# SERVICE BULLETIN

Classification: BT19-011a	Reference: NTB19-079a	Date: December 3, 2020
------------------------------	--------------------------	---------------------------

## REAR PILLAR MOLDING REPLACEMENT

**APPLIED VEHICLES:** 2016 - 2021 Maxima (A36)

Figure 2

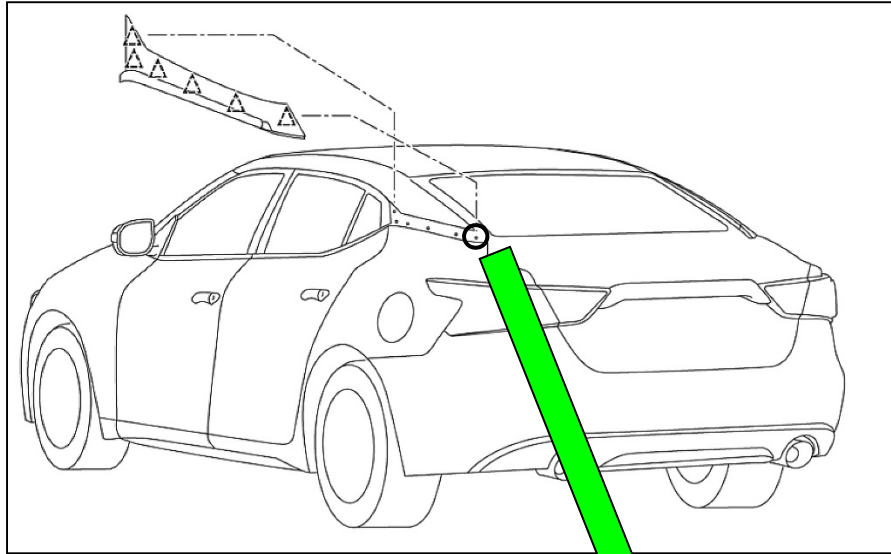
Mounting for the rear pillar molding on 2016 – 2021 Maxima vehicles now requires a 19/64<sup>th</sup> inch (7.5 mm) mounting hole for the rear clip and urethane adhesive installed in two (2) locations. **ALL** rear pillar moldings on 2016 – 2021 Maxima vehicles must now be installed using this method.

Figure 4

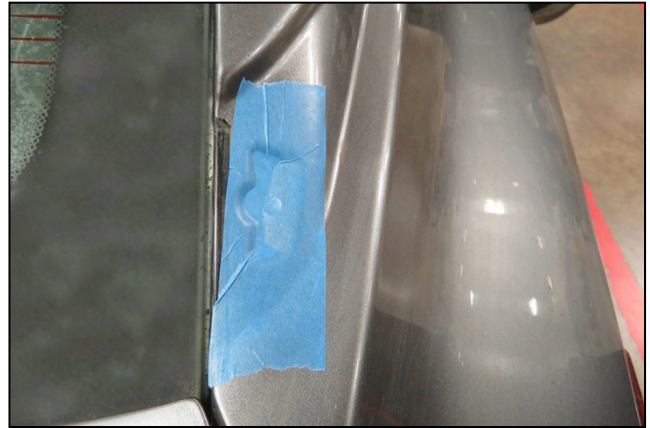
3. Apply masking tape to the 19/64<sup>th</sup> drill bit, leaving 1.57 inches (40 mm) exposed for reference purposes.

Figure 6

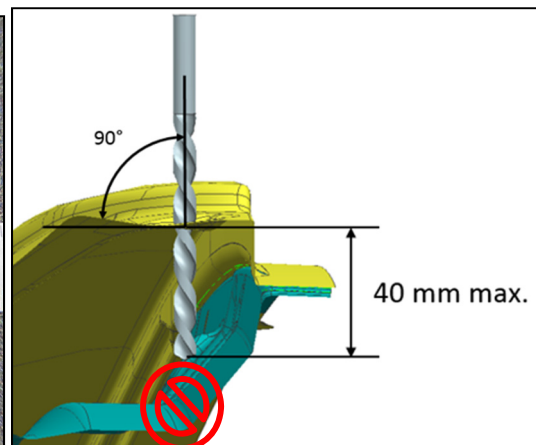
4. Drill a 19/64<sup>th</sup> inch (7.5 mm) hole no more than 1.57 inches (40 mm) deep.

To avoid damage to the vehicle, do not drill more than 1.57 inches (40mm) deep, otherwise the drill bit will contact internal body panels.

Figure 14

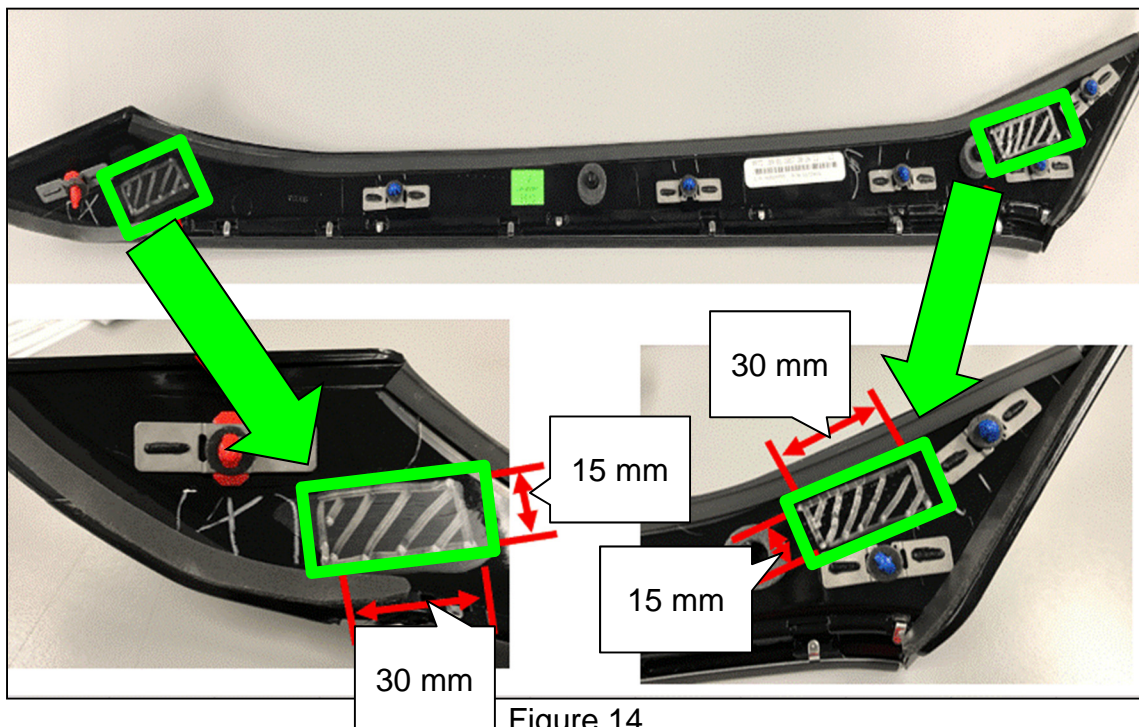
10. Apply Betaseal™ 43533 glass primer onto the newly cleaned rear pillar finisher areas shown in Figure 14, below.

Allow the Betaseal™ 43533 glass primer to dry for **AT LEAST 20** seconds or the urethane will **NOT** adhere to the rear pillar finisher.

Figure 15

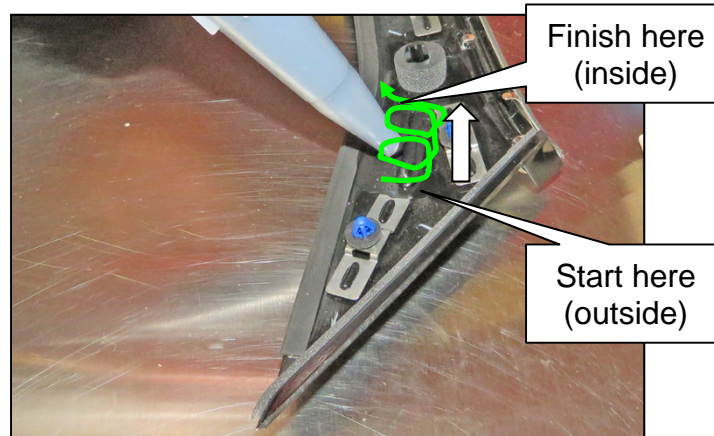
11. Apply Betaseal™ 57302N urethane in a **circular motion** starting from the **outside** to the **inside** of the rear pillar finisher, as indicated by the arrows in Figure 15 and Figure 16, below.

- Apply the urethane to a height of 8 mm and a width of 10 mm.
